Operational Alert: 162

Subject: Aileron Link Cables and Turnbuckle

Models Affected: All S-7LS and S-7S models

STATION 3

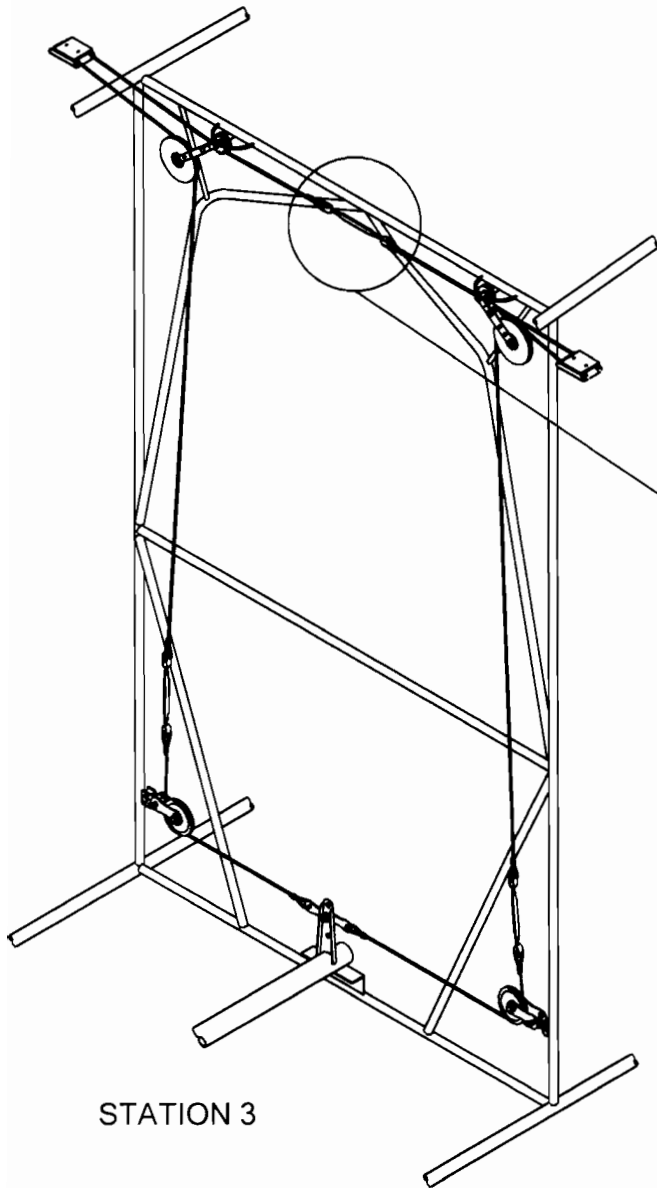
During assembly of an aircraft at the factory, we noted that only 4 threads could be engaged on the upper Turnbuckle at Station 3 (connecting Aileron Link Cables). Investigation showed that some Aileron Link Cables have been made too short.

Prior to the next flight, inspect upper Turnbuckle at Station 3 for thread engagement (Reference attached drawing).

A minimum of 6 threads should be engaged on each end of the Turnbuckle.

TURNBUCKLE IS RL-335-AT
CHANGE TO RL-335-BT
IF REQUIRED.

6 TURNS MINIMUM
ENGAGEMENT

If this cannot be assured, change Turnbuckle to part # RL-335-BT. Turnbuckle RL-335-BT is slightly longer and available from RANS Parts Department.

Refer to manual for proper rigging.
Safety wire turnbuckle after inspection, check for clearance or interference with other parts.
Perform functional check of ailerons before flight.
